31/6-94L 10221 Montgomery Avenue
Kensington Historic District

Discussion: N. Raphael and Ilene Shulman's Application for Historic Area Work Permit.

RE: Revisions to approved HAWP

Address: 10221 Montgomery Avenue Meeting Date: 10/26/94
Resource: Kensington Historic District Review: HAWP/Alteration
Case Number: 31/6-94L Tax Credit: Partial
Public Notice: 10/12/94 Report Date: 10/19/94
Applicant: N. Raphael & Ilene Shulman Staff: David Berg
PROPOSAL: Demolish portion of existing porch, construct 2 story frame addition RECOMMEND: Approve

PROPOSED
LEFT (NORTH) ELEVATION

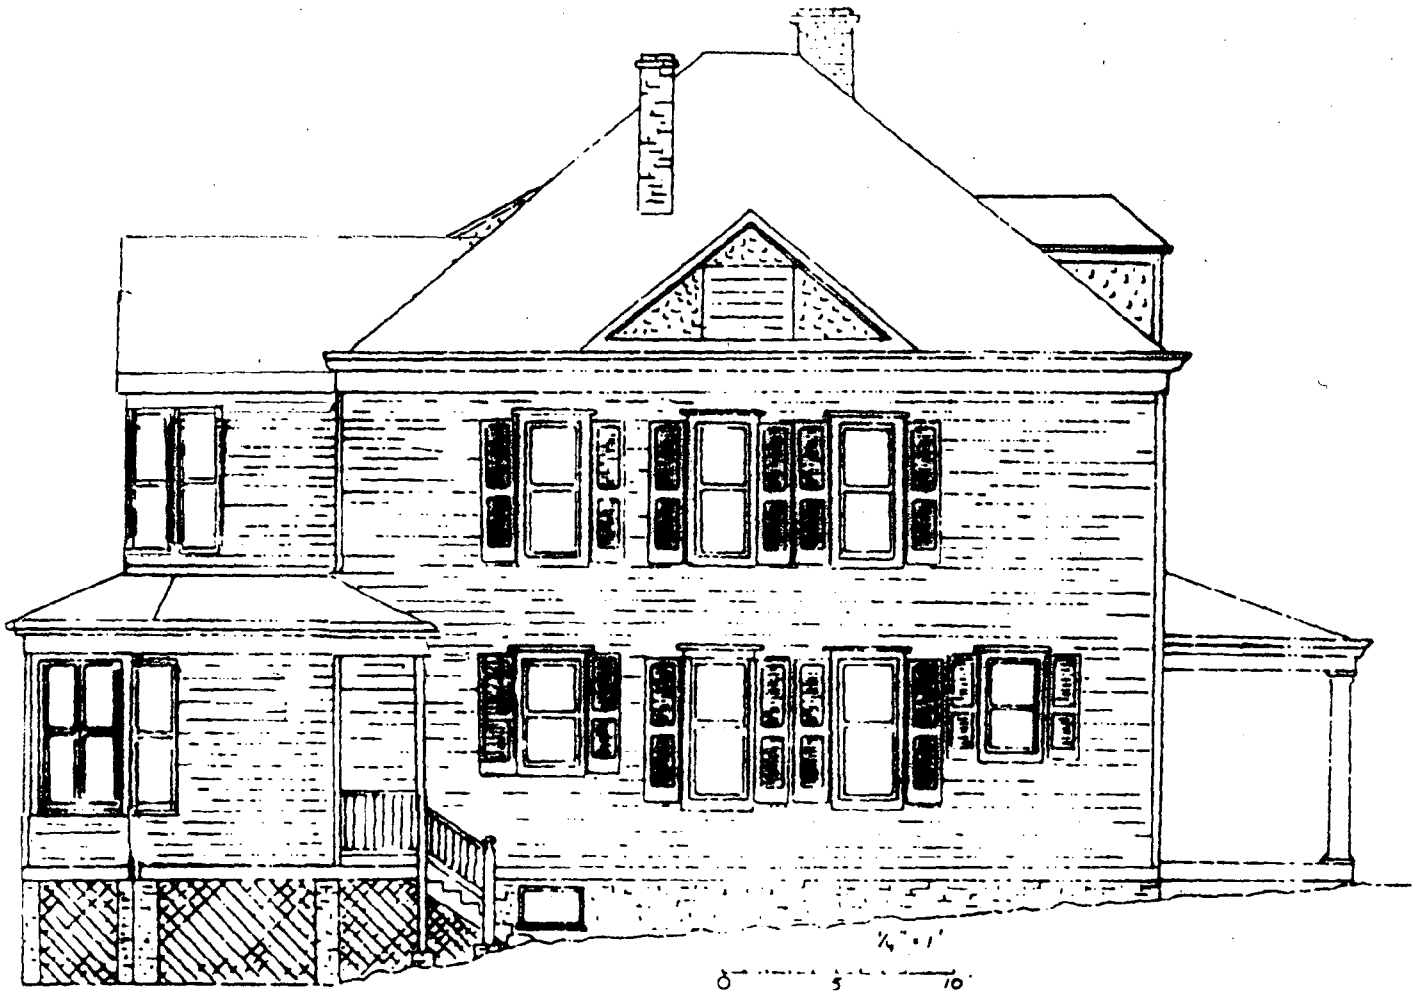
- 1) On the North elevation, you may reduce the length of the new roof at the proposed side porch entrance.
- 2) On the North elevation, you may delete the horizontal window and substitute a double-hung window in the location show on the newly submitted drawing.

- 3) On the North elevation, you may add an additional double-hung window on the second floor addition.
- 4) You may raise the height of the new addition to the height as shown on the newly submitted drawings. The new height is still below the height of the existing roof, and will not affect the massing of the addition.

- 5) On the East Elevation, you may substitute wood pickets for the solid wood rail on the second floor porch; you may add wood pickets and a railing at the first floor porch.

- 6) The taller windows at the second floor of the addition may be installed, to complement the proportions of the altered roof height. The windows will still be double-hung and installed in all other aspects as approved in the original HAWP.

- 7) On the east elevation of the rear addition, you may delete the wood panels under the first floor windows, and install wood siding to match the rest of the house.

**PROPOSED
 REAR (EAST) ELEVATION**

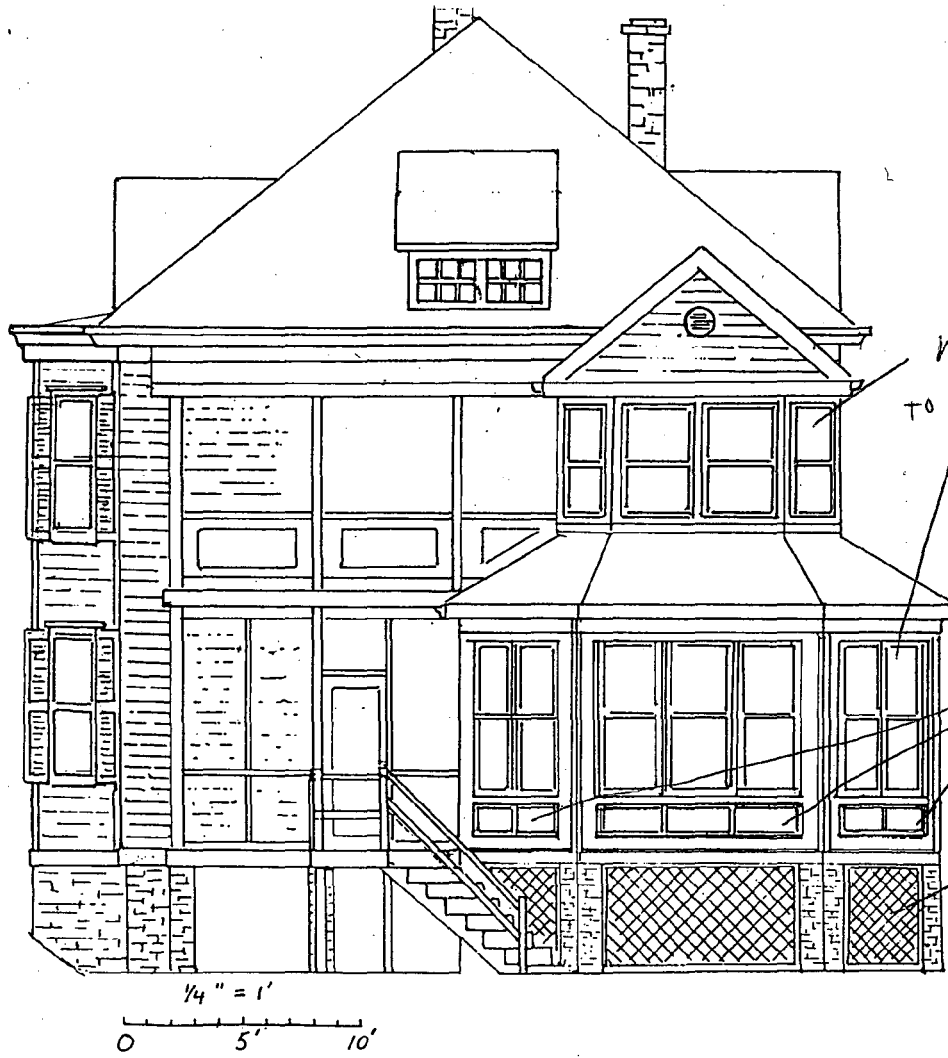
WOOD windows
 TO MATCH existing
 NO SNAP-IN
 MUNTINS.
 DCB

PANELS OF
 WOOD OR
 WINDOW
 PANELS
 DCB

LATTICE
 TO BE
 STRAIGHT
 UP AND DOWN
 NOT Diagonal
 DCB

**PROPOSED
LEFT (NORTH) ELEVATION**

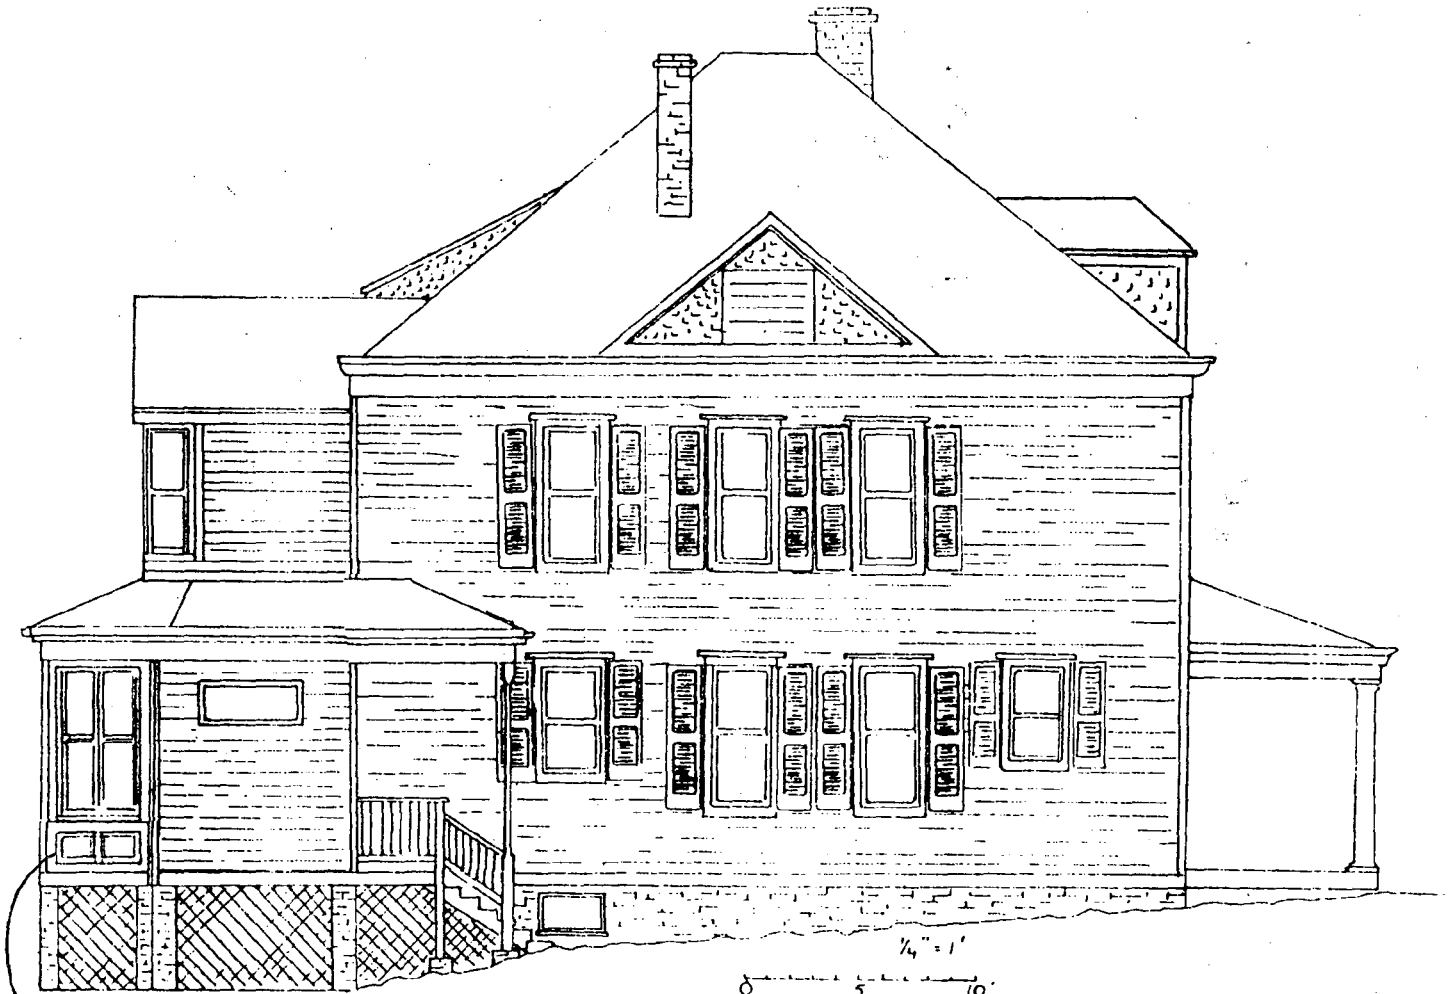
→ Panels of wood
or
window panels. DCB

**PROPOSED
LEFT (NORTH) ELEVATION**

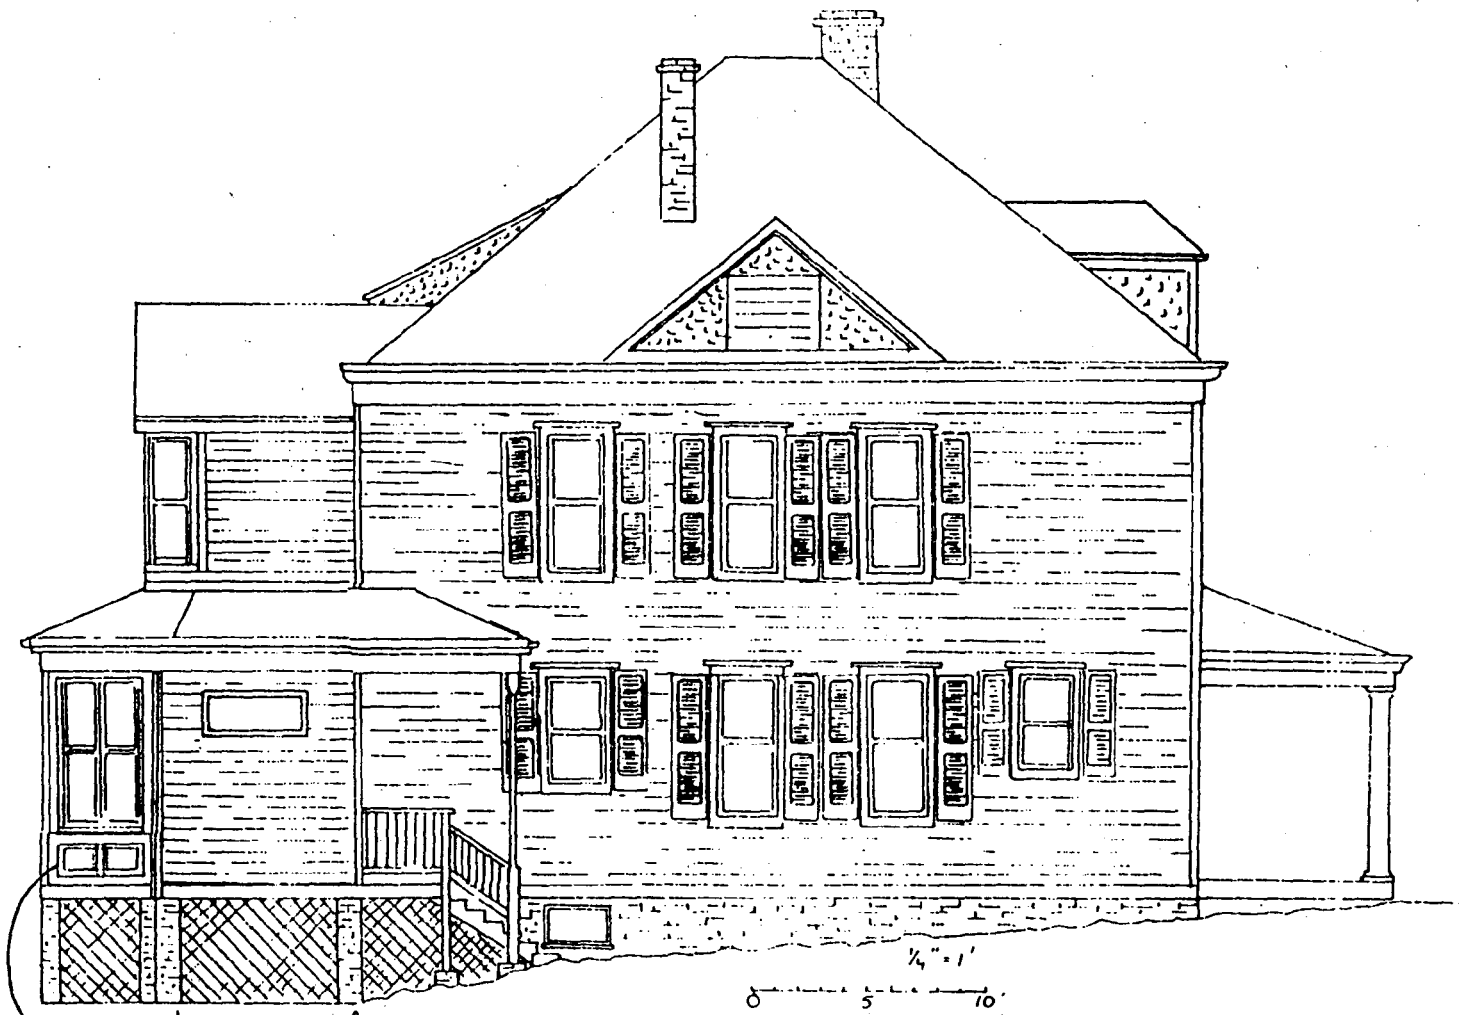
→ Panels of wood
or
window panels. DCB
